From: Christensen, Kelly
Sent: Wednesday, July 11, 2012 3:51 PM
To: 'garrettranches@heritagewifi.com'
Subject: Preliminary finding for 63-11786, 63-11787, and 63-11788
Attachments: 63-11786 et al Garrett pre license analysis.docx

PRE LICENSING REVIEW AND ANALYSIS

Shown are the proposed recommended POU shapes for the three permits.

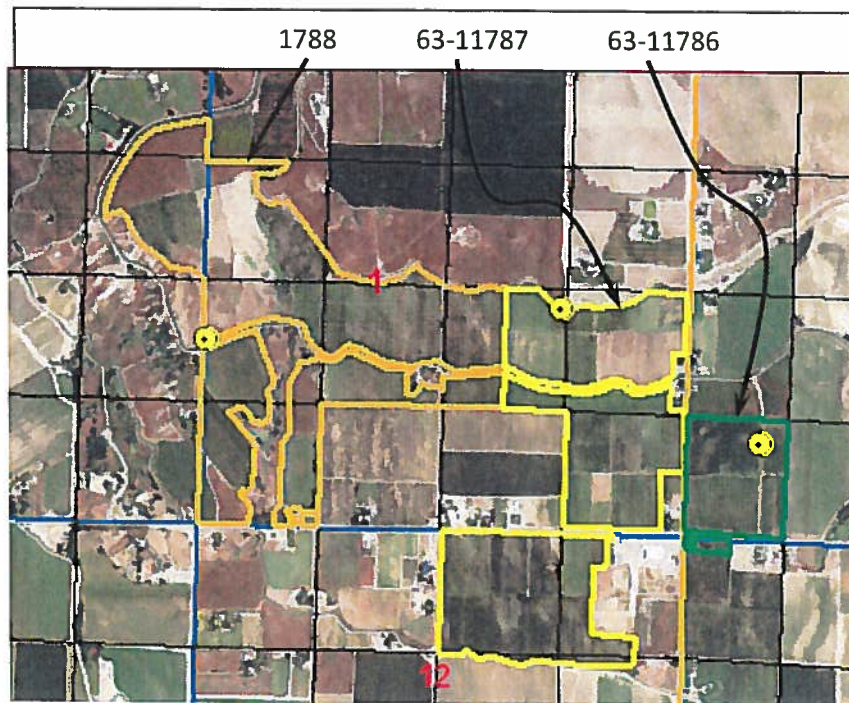
63-11786	34 acres	0.68 cfs – Rate limited to 1 inch per acre for the found acreage
63-11787	144 acres	0.80 cfs – Rate based upon 40 Hp, static level of 188 ft and a 100 ft drawdown, and open discharge (nominal pressure of 10 PSI)
63-11788	177 acres	2.32 cfs – Rate based upon 100 Hp, static level of 142 ft and a 100 ft drawdown, and open discharge (nominal pressure of 10 PSI)

I decided to provide you with this information for your input prior to completing the recommendations for licensing. My concern is primarily the calculated rates for 63-11787 and 63-11788. As the values are based upon estimates or well log information that may no longer be representative of current conditions I wanted to confirm that they are acceptable to you. I used a drawdown value of 100 ft based upon well driller tests for some other wells within 2 miles of this location as that information was not available for these rights. Obviously the rate for 63-11787 is the biggest concern. The theoretical calculation gives a diversion rate less than one half an inch per acre. The formula used is shown to the right.

$$\frac{40 \text{ Hp} * 8.8 * 0.7}{(10 \text{ PSI} * 2.31) + 288 \text{ ft}} = 0.792 \text{ cfs}$$

Obviously the best way to resolve the concern would be to turn the well on and route the discharge so that the flow would go over the weir at the point of discharge. Alternatively would be to get more accurate values for the dynamic pumping level.

During the field examination for the three rights we discussed the possibility of a transfer tying 63-11786 and 63-11787 together through a transfer. Along with this or alternatively the well associated with 63-11786 has excess capacity as it was originally developed for a significantly larger POU. You might want to consider filing an application for permit for this well to be used on the POU covered by 63-11787 and possibly a portion of 63-11788.
